#### NOTICE OF VIOLATION

On May 7, 2025, Energy Safety conducted an inspection of Southern California Edison Compnay's WMP initiatives in the vicinity of the city of Moreno Valley, California. The inspection report is enclosed herewith. Energy Safety found the following violation(s):

## **INSPECTION REPORT**

Exhibit D: Photo Log **Structure ID:** 4491252E

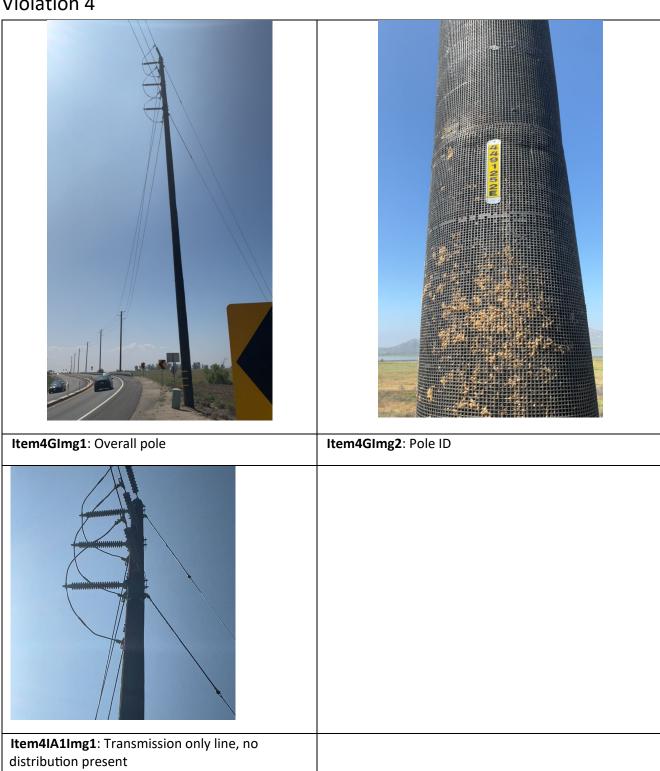
Violation 4: On pole ID4491252E, Grid Hardening ID 410903684-4491252E at 15759-15859 Gilman Springs Rd, Moreno Valley, CA, 92555, USA, 33.893433561885, -117.080986133899, the inspector observed that the tower carried only transmission infrastructure, even though a distribution infrastructure-related initiative was reported completed at the location. The inspector's observation is documented in Violation 4 photographs, which are an attachment to this report. Photo number Item4IA1Img1 depicts only transmission infrastructure, and no distribution infrastructure, while the distribution infrastructure-related initiative was reported complete at the location.
